TEAMRISE BELL TOWER

2302 4th Avenue DPD #3018968

Recommendation Meeting April 17, 2018

EDG RESPONSE: MASSING - OPTION 1 PREFERRED

GASKET OPTION STUDY

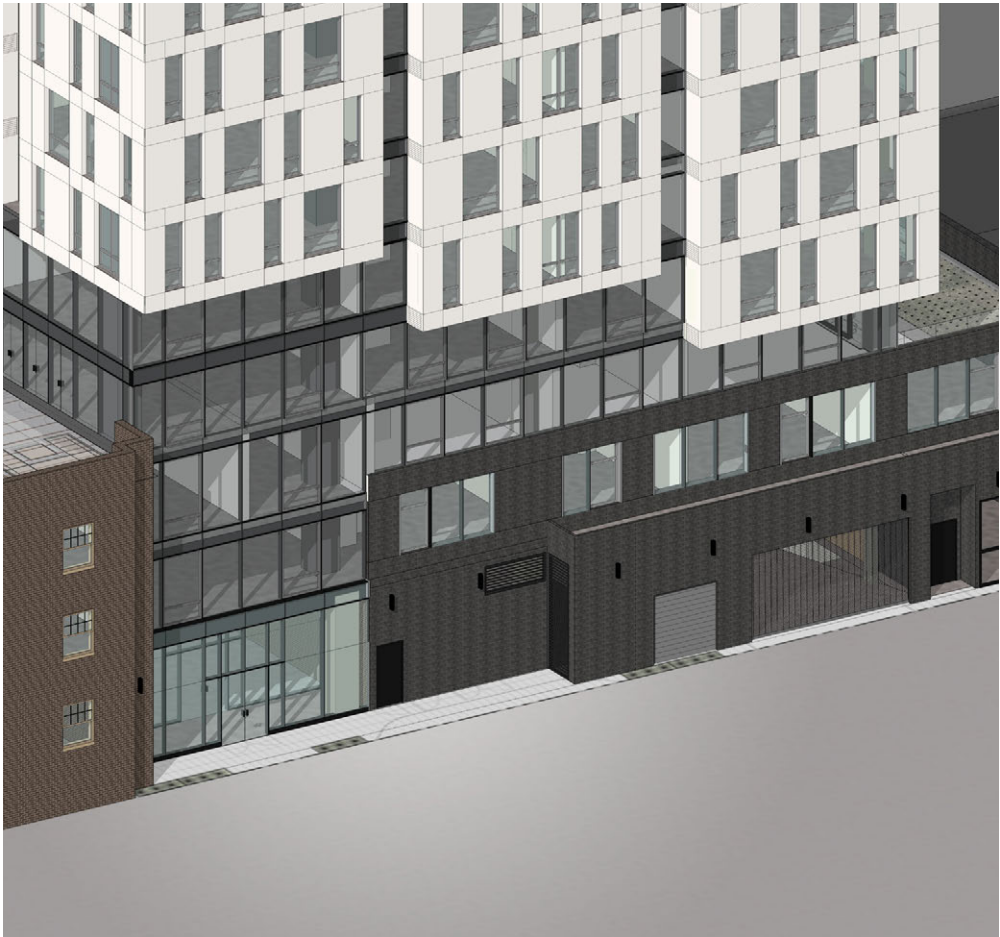
- c. The Board was very pleased with the gasket concept and change in materiality provided between the solid podium and the tower. The Board felt, however, that the gasket expression should be stronger and more legible, particularly on the north end (at the lowest point). This minimal condition is well represented on page 53 of the packet. Echoing public comment, the Board noted that this gasket and “lift” should read clearly from both the east and west. (B1.III, B4, B4.3)
- d. The Board appreciated the taller dimension of the gasket on the south side which appears to lift away the mass of the tower away from the landmark structure providing deference in this gesture. (A1.1, B1, B1.1, B1.I, B1.II)

The Board felt the gasket expression should be stronger and more legible.

The MUP package maintained the strength of the three incremental steps at the underside of the tower. With the initial feedback from planning, we have adjusted this to strengthen this horizontal, stepped reveal by creating a higher space between the underside of the lowest tower element and the parapet of the two-story brick retail/residential podium. We lowered the brick parapet above the second level and added a setback glass guardrail at the third-floor roof deck. This more clearly separates the tower from the podium and creates a more functional view out from the units at the third floor. In addition, the underside of the tower stepped soffits will be lit to further enhance the feeling of the floating tower. This is the main source of the building lighting and the remaining lighting effect will be from the ambient light glowing from the atrium/paseo, the retail signage and canopy lighting.

NOTCH AXON

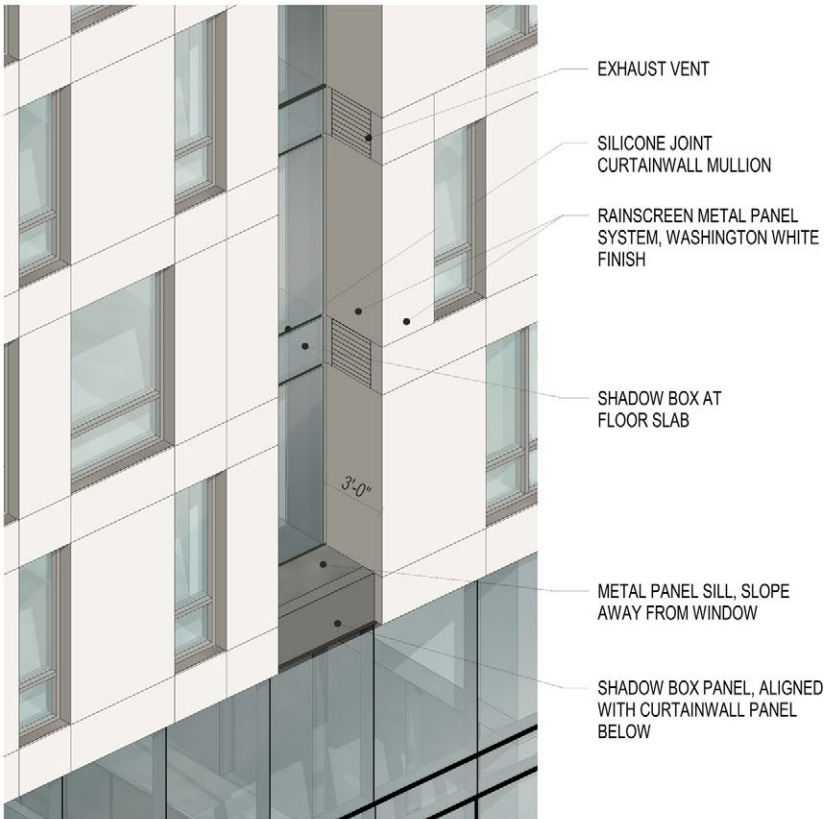
- e. The Board appreciated the three bays terminating at different levels, however the Board did not reach consensus that this was critical to the success of the design.
- f. The Board was very supportive of the deep vertical notches that run the height of the tower, providing distinct articulation and texture reminiscent of the verticality expressed by the landmark structure on either side of the tower. (A1.1, B1, B1.1, B1.I, B1.II)
- g. The Board agreed with public comment and strongly supported the consistency of this vertical notch expression on all four building facades, keeping a strong and coherent architectural language as viewed from all directions. (B1.III, B4, B4.1)

The change from a square notch in the EDG plans and the current design in the MUP package is a design decision to help better express the reveal and a result of the unit planning and layout. In the design concept, the vertical reveal helps to create the expression for 9 sliding masses of the tower. These are the pearl white volumes with alternating punched windows. The three elements on each side are divided by the reveals. We are showing the metal panels returning into the reveal to express the volume. With the lighter color returning back to the glass reveal, it will be reflected in the glass. This should create the impression that it is twice as deep as it is actually. So while the notch is now approximately 3' deep with is still very deep, it may appear to be closer to 6' deep (rather than the previous 5' with dark sides). This is a more elegant volumetric solution rather than the previous expression with was too planar. Also as we begin looking at the unity layout and the really deep 5' notch was too disruptive to the furniture layout especially in the smaller studio units.

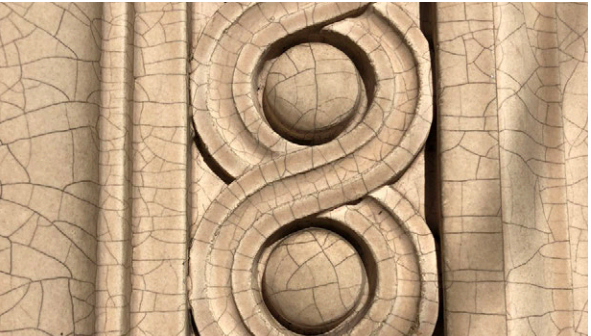
- a. Related to 2c above, the Board would like to see further exploration of materials and texture to pursue a contemporary design but also include fine craftsmanship and detailing (overhead canopies, mullions, etc.) to reflect the Belltown character. (A1.1, B1, B1.1, B1.I, B1.II, B1.III, B1.IV)

- b. The Board noted that the glazing scale is critical and should be sized and designed to fit into the Belltown context with proportions that reflect the residential functions. (A1.1, B1, B1.1, B1.I, B1.II, B1.III, B1.IV)

The design of the podium levels 1-4 has been further refined following the Board’s feedback. The overall podium concept is to relate to the local context through material and proportions while keeping the details very clean and simple to allow the retail shop interior to show clearly onto the street life. While the two-level podium is brick, it is a contrasting color to the historic building on either side. The Gray color Manganese Ironspot smooth brick veneer has a variation and sheen to give it richness and depth in different light. The module of retail storefront has been set to a more human scale of about 3’-0”. The rhythm of mullions is strengthened with a larger 3” mullion at each door to accent the entry and the remaining area subdivided into 3 lites with narrower mullions. The head of the door also creates a stronger band with a clere story above. A decorative louver at the head of the opening gives flexibility to retail use and the opening is capped with a Blackened Steel header. The canopy above is dark gray steel cantilevered from the intermediate brick banding. It is a similar spacing to the glazing with fritted glass canopy lifted off the steel for continuous weather protection along the new areas along 4th. At each brick pier downlights on either side of the steel beam project light onto a blade signage element centered in the pier 7’ off the sidewalk. The depth of glass canopy varies along the street with the atrium entry being the deepest as it steps up slightly as well.

The retail glazing has been sized down to 3’ spacing while the atrium glazing spacing is still larger at 5’ to provide feel of indoor/outdoor. The residential tower windows range from 2’-6” to 5’ which is slightly larger than the existing Franklin apartments.

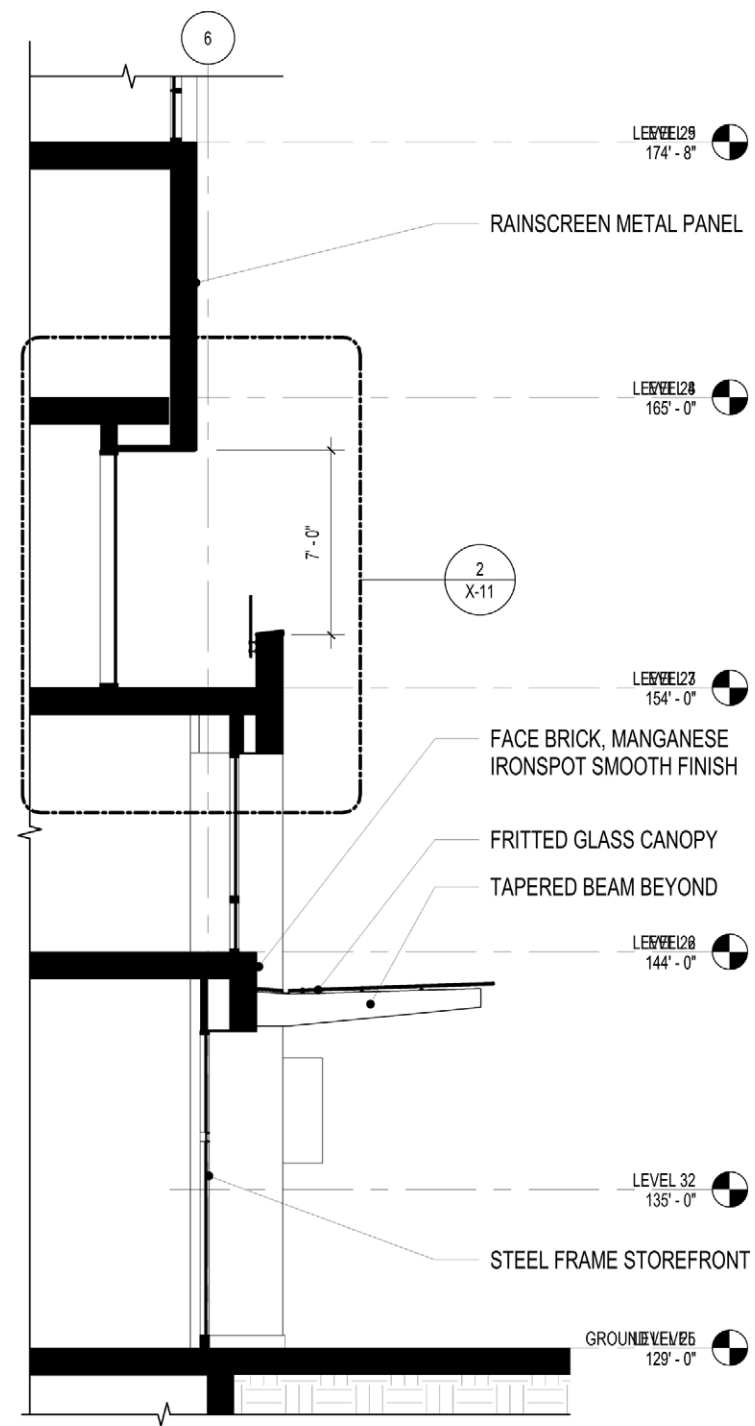
The Board noted that the detailing of the podium and gasket feature will be critical. The Board noted that the proportions of the pedestrian as it relates to the podium materials would be helpful to understand in terms of evaluating the response to this guidance. At the next meeting, they would like to see details regarding the tower soffit, all building materials and a conceptual signage plan. (B1.III, B1.IV, B4.3, D4, D4.4)

The reveal between the 2 story brick podium and the floated pearlescent tower or the gasket has been increased in height to 7' by lowering the brick parapet at Level 3 and providing a recessed glass guardrail. The soffit at the underside of the tower elements is the same pearlescent material along with the returns on the sides to the vertical reveal. The underside of the tower soffit is edge lit from glass head outward to create a floating feeling at night. Exterior exhaust vents are also placed in the side panels of the reveal returns at the ceiling line. Retail signage is a simple perpendicular blade (14"x4") sign at each of the brick retail podium piers under the canopy. These are lit from the downlights in the canopy.

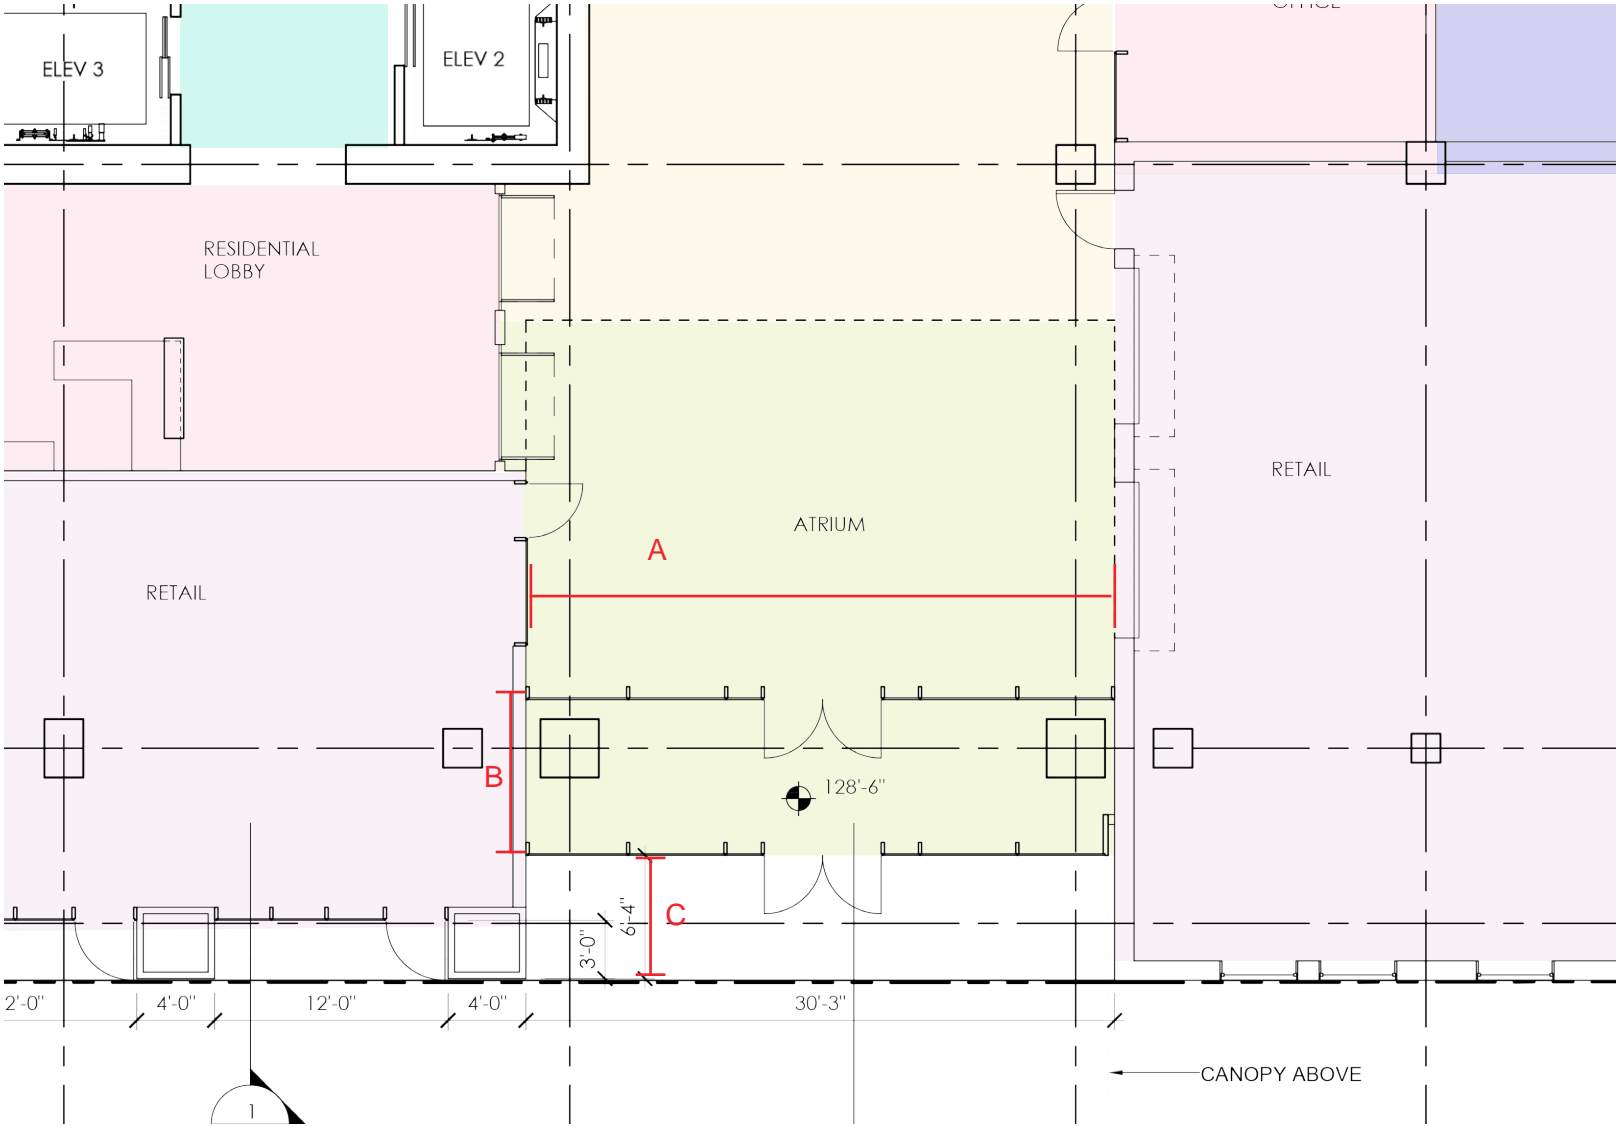
- d. The Board noted that the size of the entry vestibule will also be important for the intersection of the atrium and the sidewalk and how this atrium space is visually accessible and interactive with the streetscape. (B1.III and B1.IV)

The vestibule is essentially a transparent enclosure running across the front of the atrium and is capped by glass in the same plane as the canopy.

Dimensions:
A: 30' - 3"
B: 8' - 0"
C: 6' - 4"
